FACILITY: VIRGIL C. SUMMER NUCLEAR STATION, UNIT NO. 1

SUBJECT: MEETING SUMMARY - IST AND LICENSING ACTION STATUS

AGENDA FOR NRC MEETING ABOUT IST PROGRAM

IST SER APPENDIX B ANOMALY NUMBER 3 RESPONSE

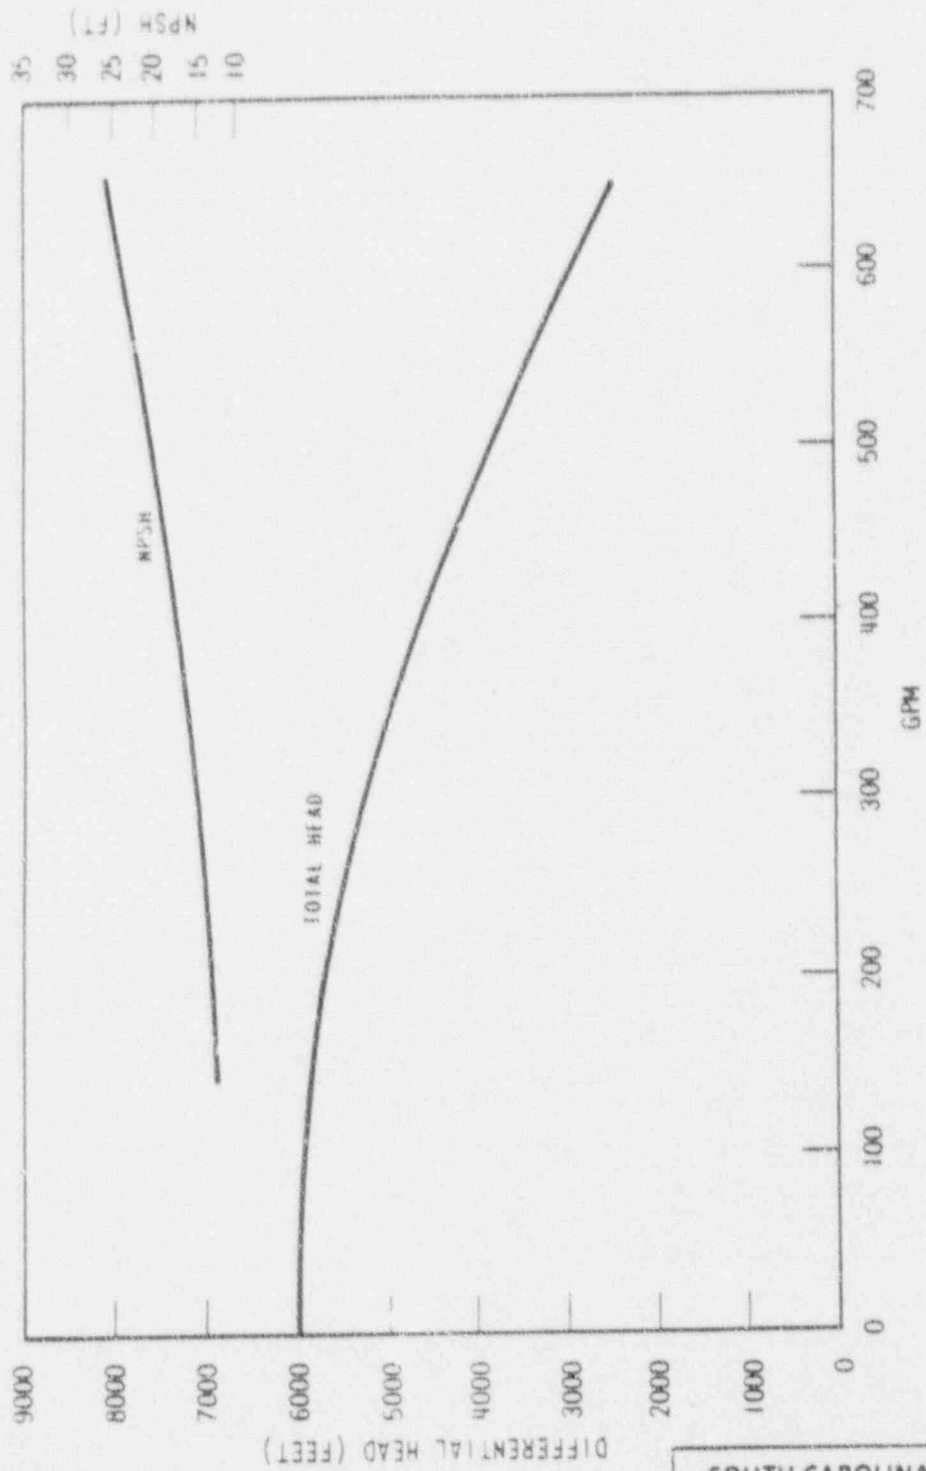
VCS withdraws Relief Request Pump E.2. The modification to add flow elements IFE-4586 and IFE-4587 has made it unnecessary.

Figure 6.3-4

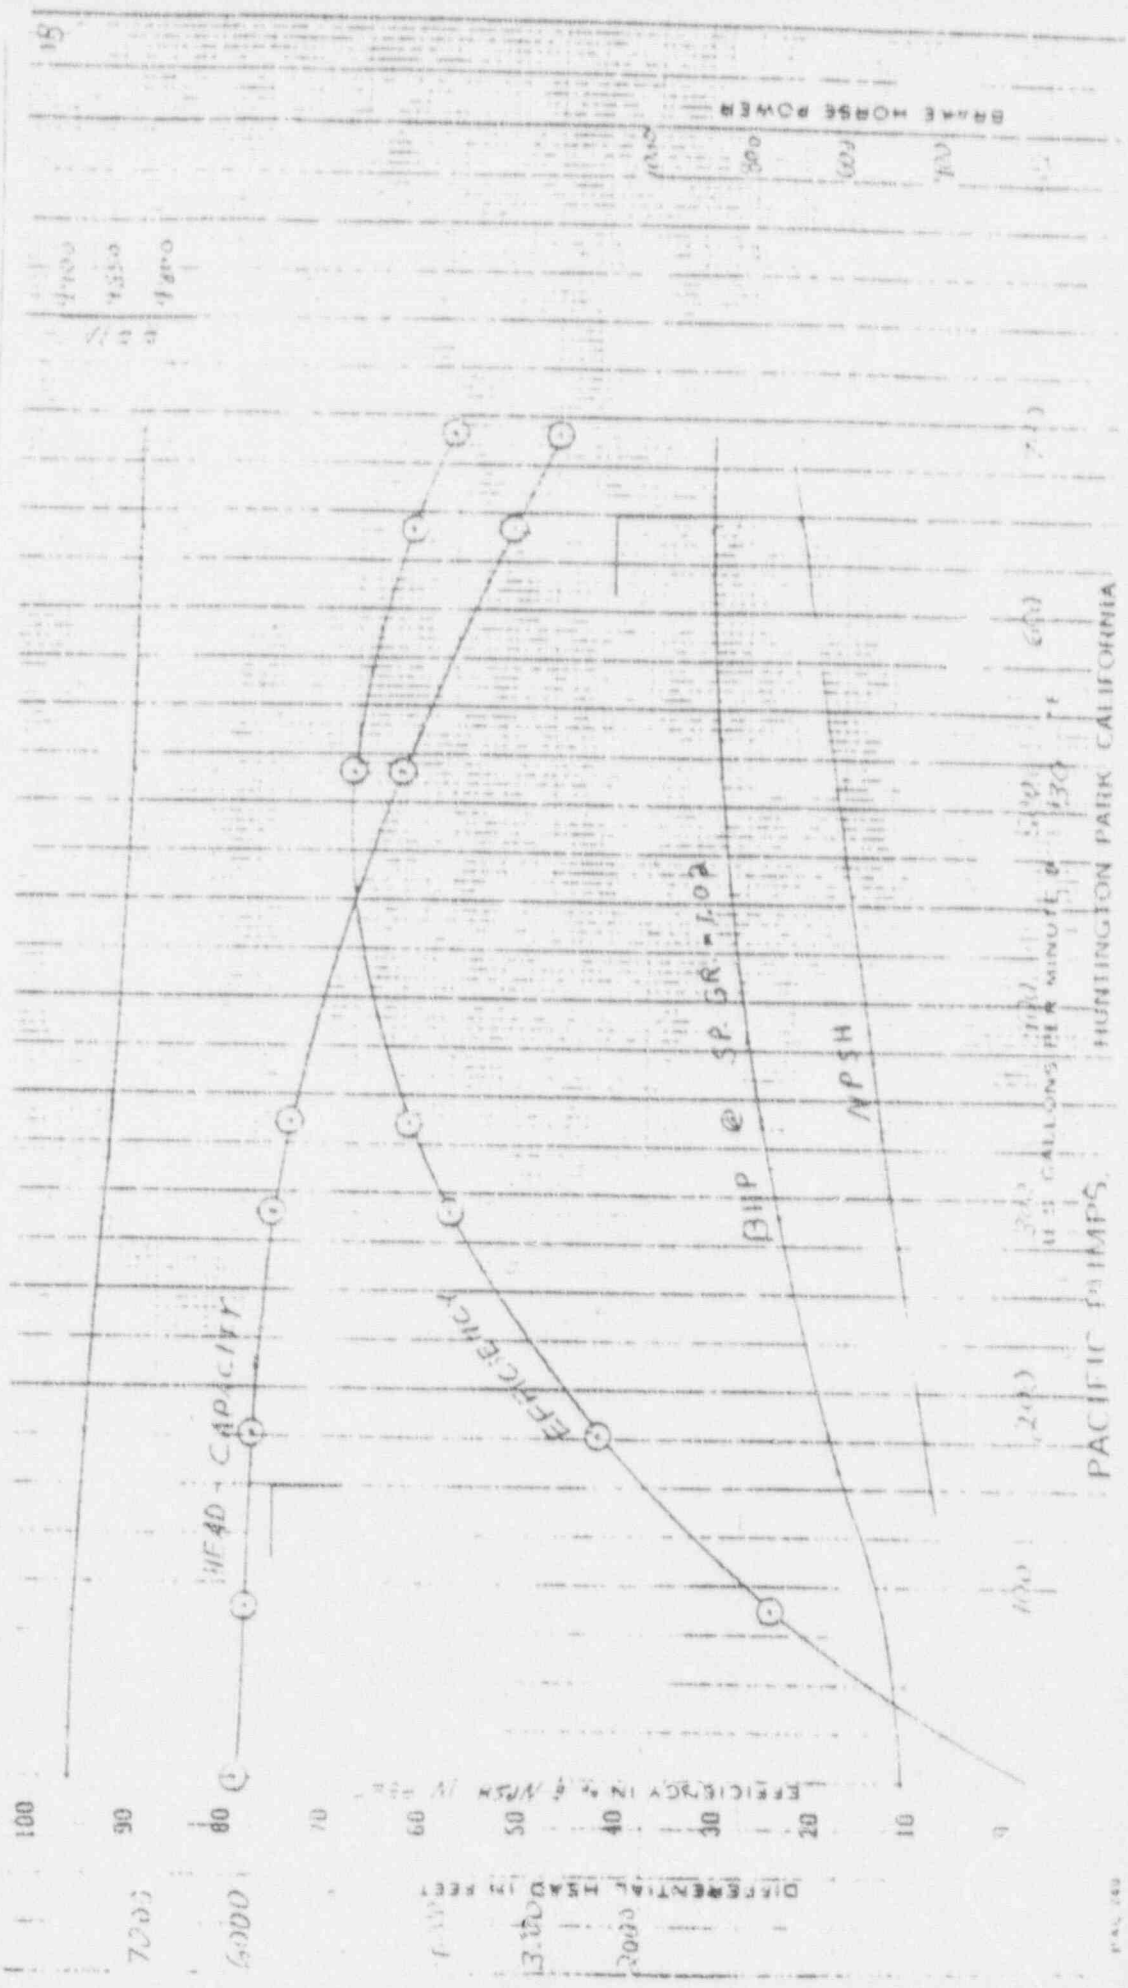
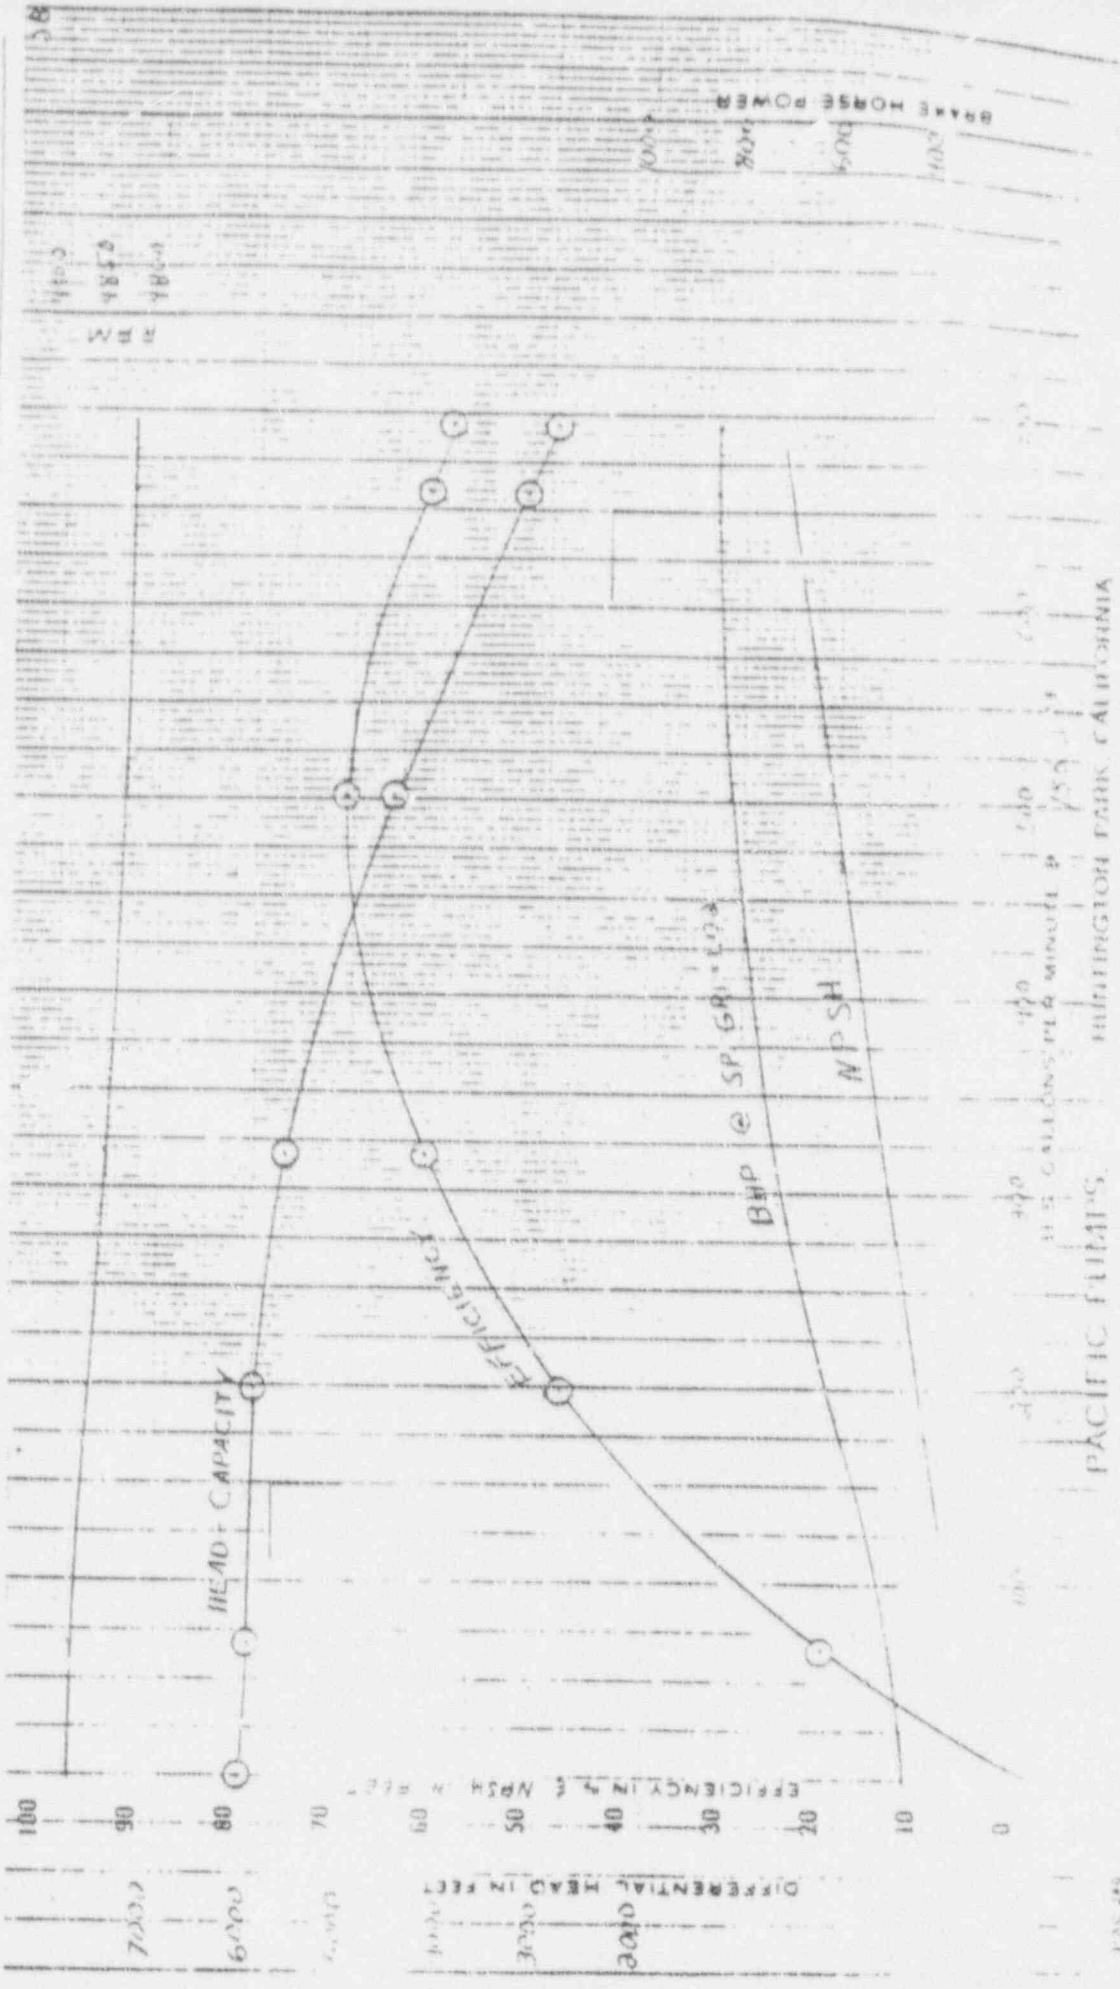
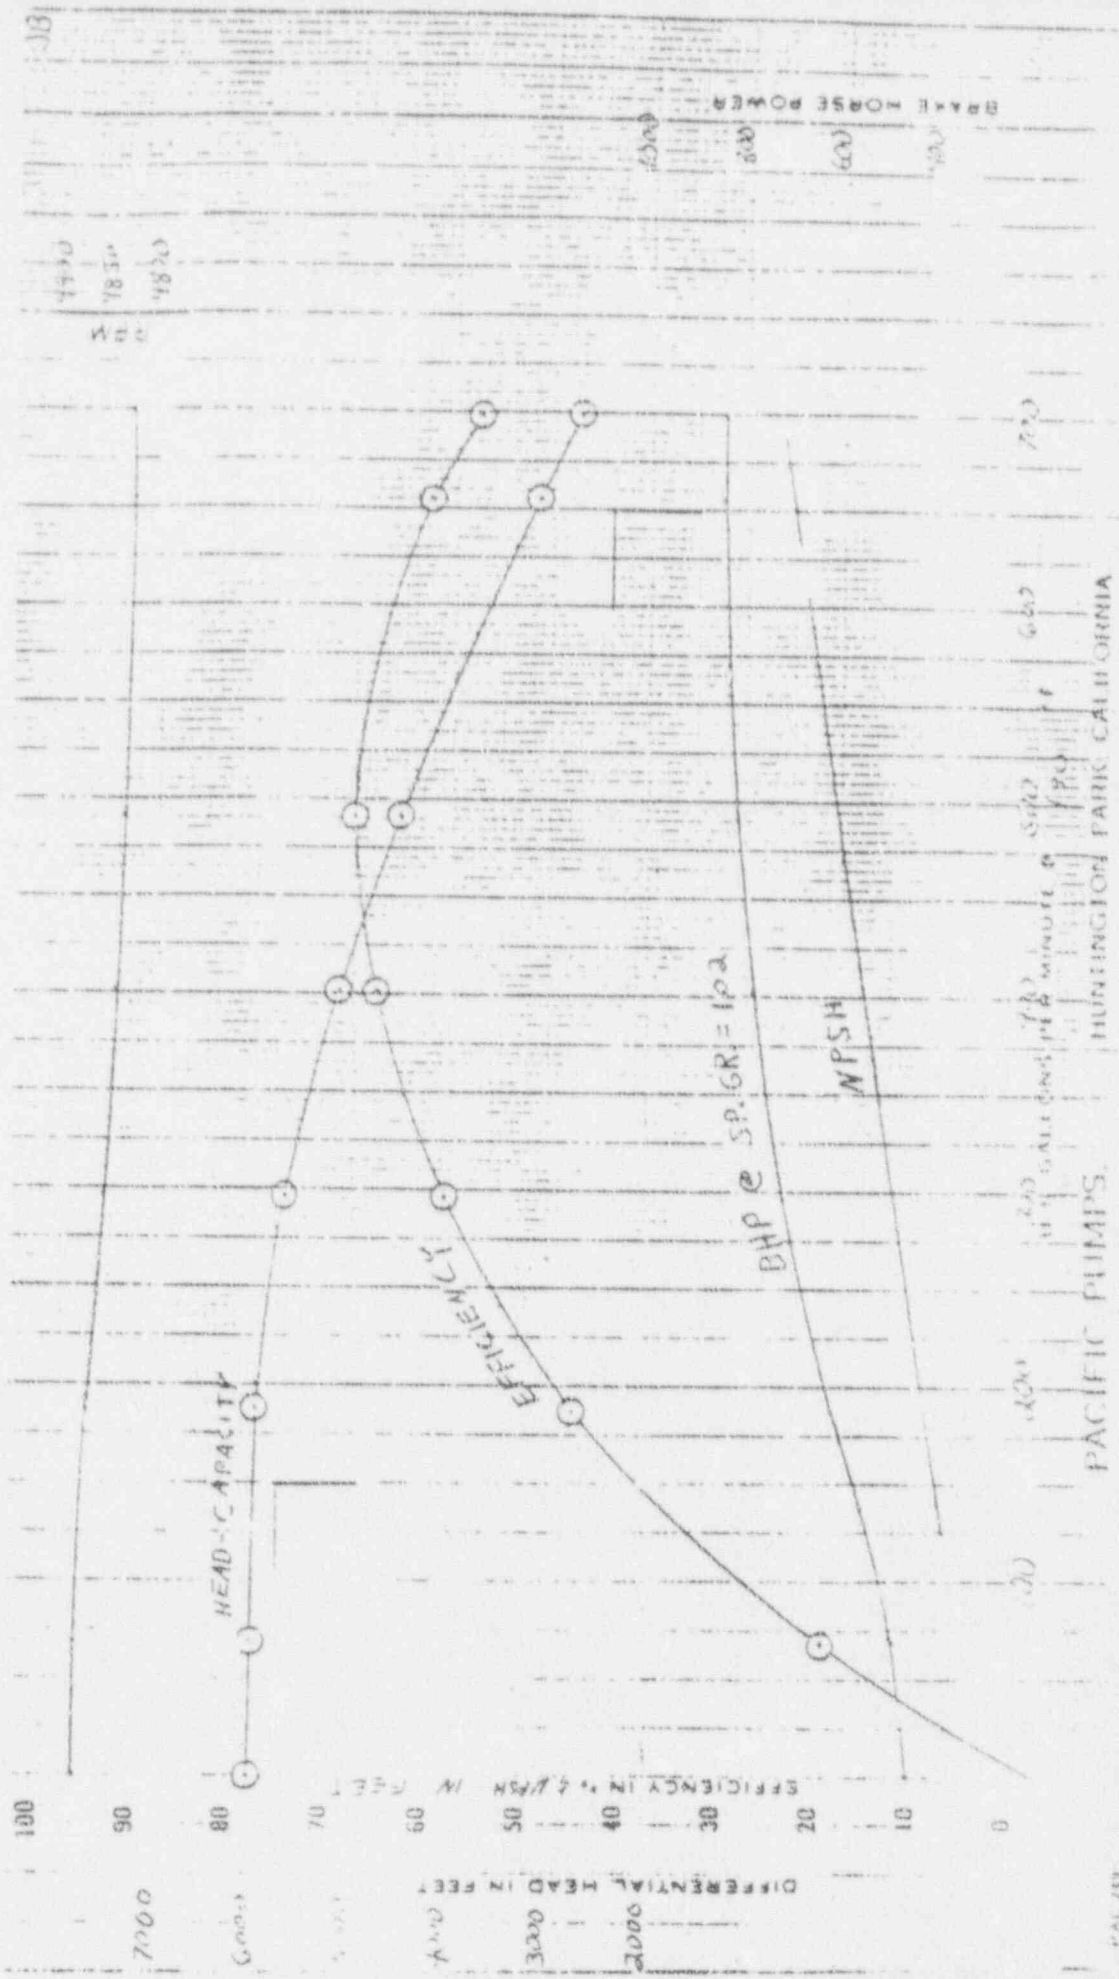
VCS is presently in compliance with GL 89-04, Position 9 which specifically addresses testing pumps on mini-flow.

Clarification of Arguments for Anomaly No. 4

1. Testing via the normal charging path requires manual operation of charging flow and poses some risk of causing a plant trip as a result of either a self induced transient or inadequate operator response to a plant transient.
2. Testing via normal charging requires closing the charging pump mini-flow valve which poses some risk of damaging the pump if there were an SI actuation resulting from a transient which increases RCS pressure.
3. As indicted by the attached curves from the FSAR and the pump manufacturer, there is very little change in DP in the 100-200 gpm range which would indicate that a test in this flow range may not detect minor pump degradation.
4. Testing in the above fashion requires installing smart transmitters in posted High Radiation areas.
5. Testing via normal charging requires testing the "on service" pump - a departure from present plant philosophy.
